IA-E-115  
1/1/79

SECONDARY SYSTEM

Subject: Transfer of Hydrogen from Waste Gas Stopage Tanks

### 3 SCHEMATIC

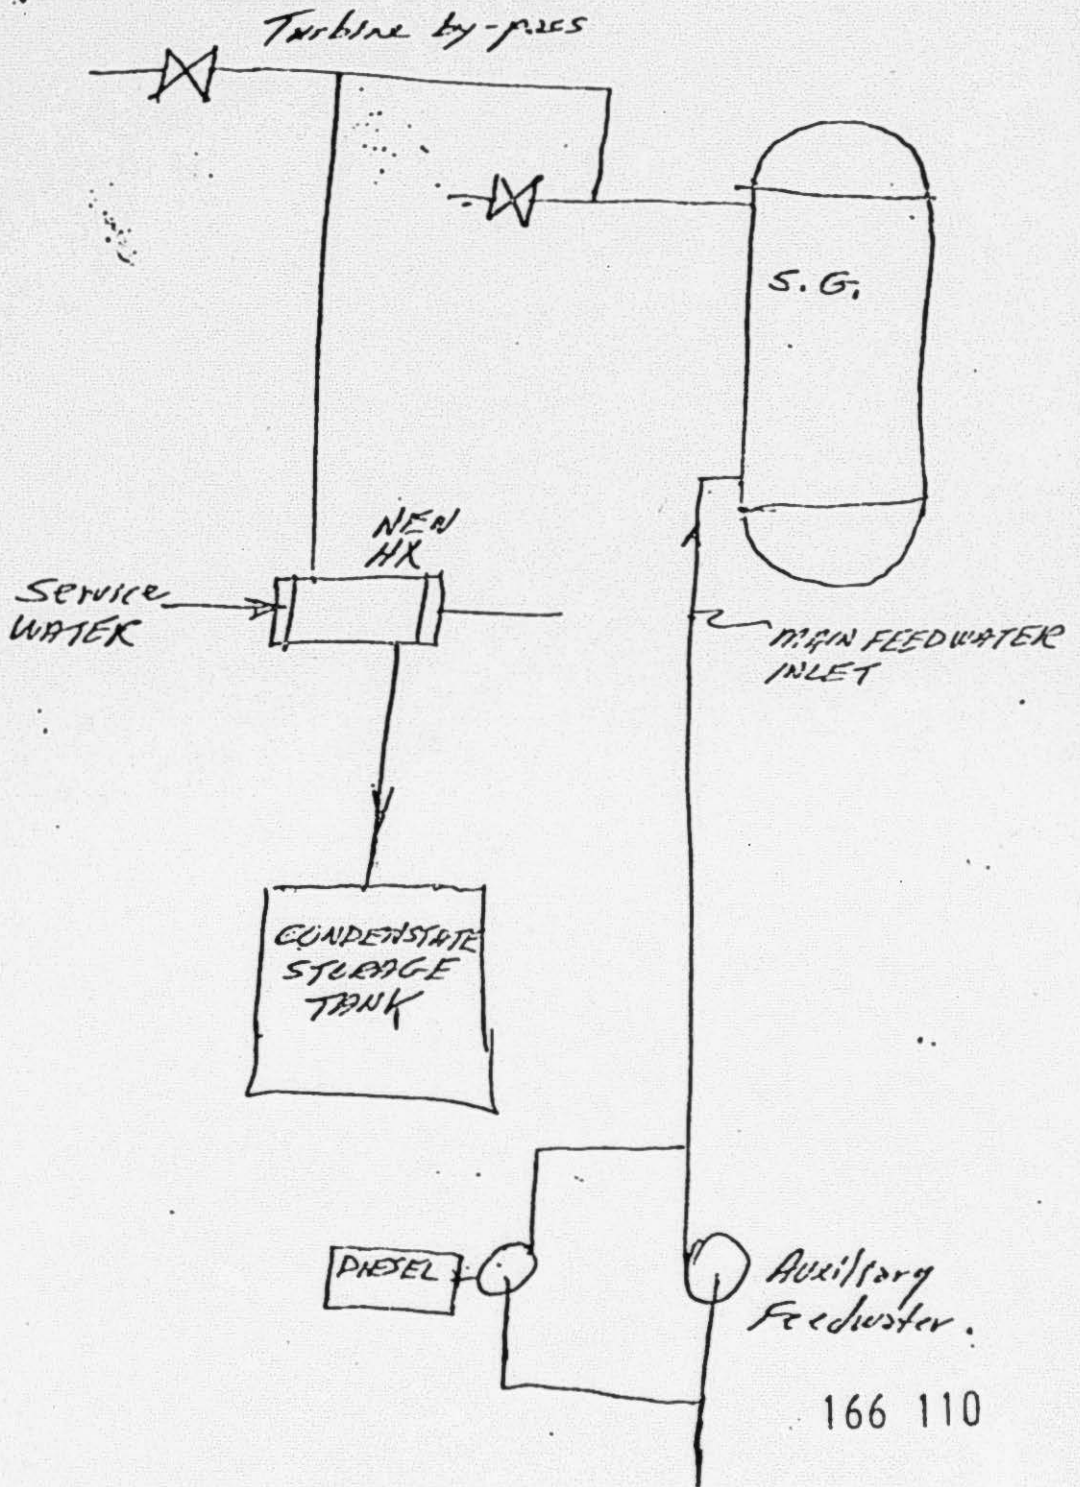
Engineer and detail design system modification as outlined in first example in paragraph II and shown in schematic paragraph III, and install as soon as possible.

During the detailed design phase of this design, installation of heat exchanger as described in 2nd example in paragraph II should be explored to determine benefit to safety and reliability of reactor cooling facility and difficulty to accomplish.
